## **PLAN CHANGE 71 ROLLESTON TRANSPORT RFI RESPONSE:**

1. Please find below a response to the transport matters raised in the RFI response from Selwyn District Council in respect of Plan Change 71 in Rolleston. Each matter has been responded to in turn.

*Table 5.2.1 - A rough guide for specifying Extra Bunching when the Input option is selected*

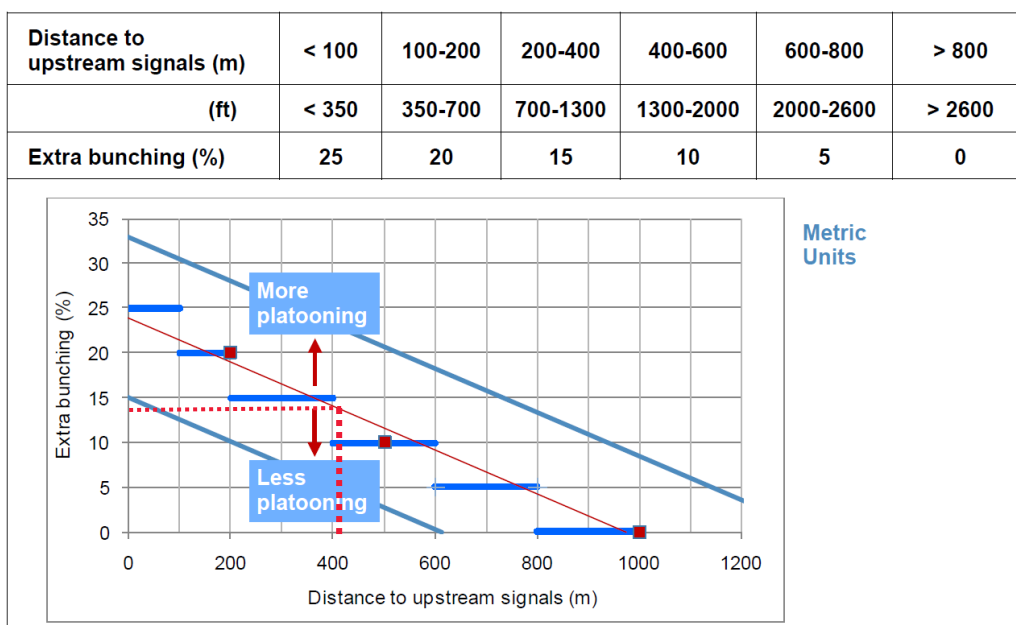
*I note a couple of LoS E issues with the Ruby Drive/new ODP road intersection etc on Levi Rd. As Levi Rd is the main arterial route from the Weedons Interchange it is important that this route is still effective. I would like to query what more could be considered here.*

8. Regardless of the above, we have reassessed the capacity of the Levi Road / Ruby Drive / Proposed Road intersection in light of the proposed traffic signals at the Levi Road / Lincoln Rolleston Road / Lowes Road / Masefield Drive intersection. The traffic lights will result in some bunching of traffic (i.e., gaps in traffic will occur between signal phases), which will make it easier to turn at the Levi Road - Ruby Road intersection.

9. The Levi Road / Ruby Drive intersection is approximately 420m from the Lincoln Rolleston Road - Levi Road intersection and based on Table 5.2.1 of the Sidra Intersection User Guide a bunching factor of approximately 13% is appropriate.

10. Once this is applied to the SIDRA Model the through and right turn movements are predicted to operate at LOS D<sup>1</sup> in the morning peak hour as shown in the movement summaries in **Attachment 1**. In the evening peak hour, the right turn movement remains at LOS E but with a delay of 35.9 seconds it is on the threshold with LOS D (being 25-35 seconds). There is a relatively small volume undertaking this right turn movement (26 vehicles per hour) and as outlined above there are alternative routes available if drivers find this delay to be unacceptable.
11. For these reasons we consider that the basic intersection layout shown in the TA and signalisation of the Levi Road, Lincoln Rolleston Road, Lowes Road, Masfield Drive intersection is the most preferable outcome.
